Subject: ORDERING REQUIREMENT FOR AT COMPONENTS FOR H3T (INLINE 6)	Service Alert No.: SA-061/26
	Last Issued : 09/16/2026

Use this guide before ordering or replacing an AT component on applicable H3T vehicles.

1. Water hose discontinuation

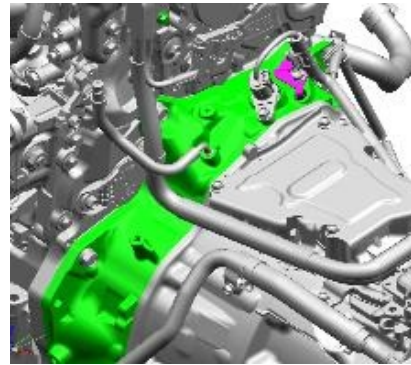
Early production vehicles were equipped with a water hose that was later discontinued. When replacing the AT component on vehicles that require water hose removal, remove the water hose. Current service AT components do not include a provision for water hose installation, and the hose does not need to be reinstalled.

**Prior to water hose discontinuation
(water hose shown in purple)**

**After water hose discontinuation
(harness bracket shown in purple)**

2. Inverter is not included with the service AT component

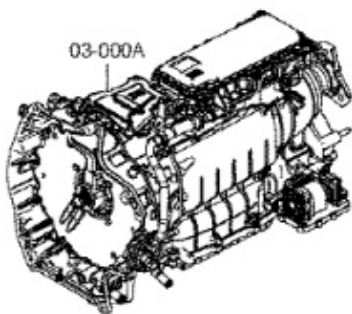
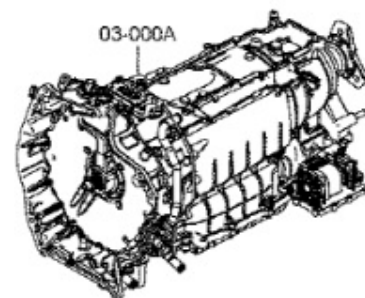
The inverter is reused and is not included with service AT components. Before ordering, check the AT component part number in GEPC and use Table A or Table B to order all required parts together.

AT component with inverter

Service AT component without inverter

IMPORTANT: If DTCs for inverter are present or WSM indicates inverter replacement is needed, order inverter separately.

3. Oil hose and oil pipe design change

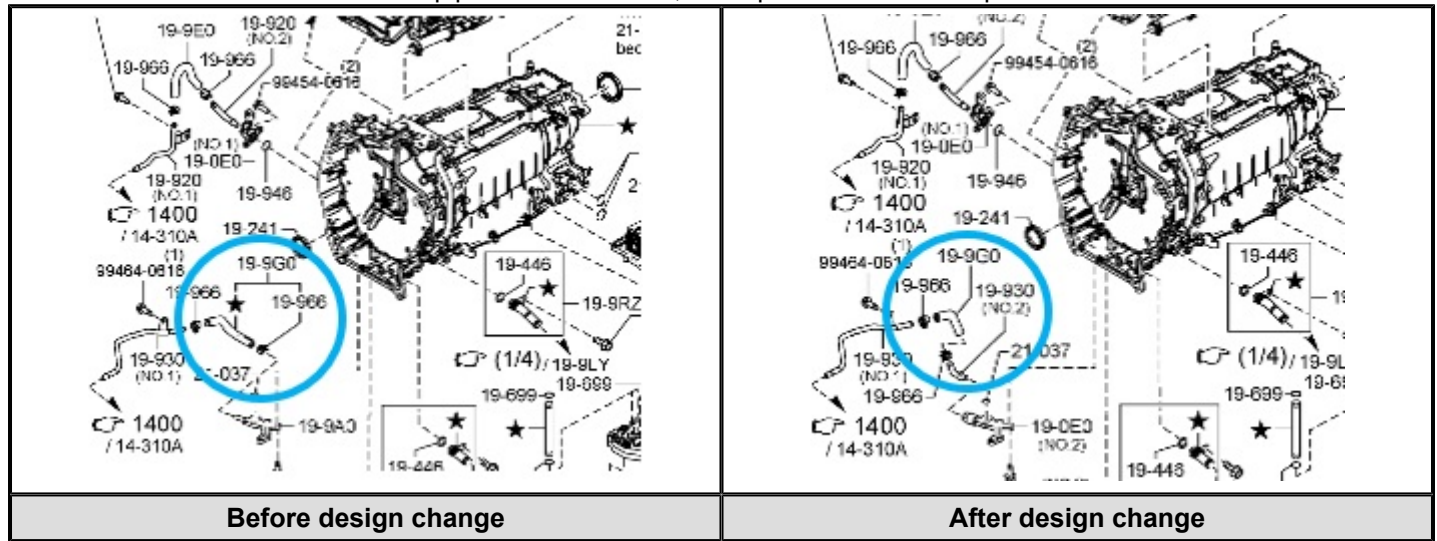
The oil hose and oil pipe were redesigned and are not interchangeable with previous-design parts. When replacing the AT component, the oil hose and oil pipe must be replaced together with the AT component.

IMPORTANT: If the oil hose and oil pipe are not ordered, the repair cannot be completed.
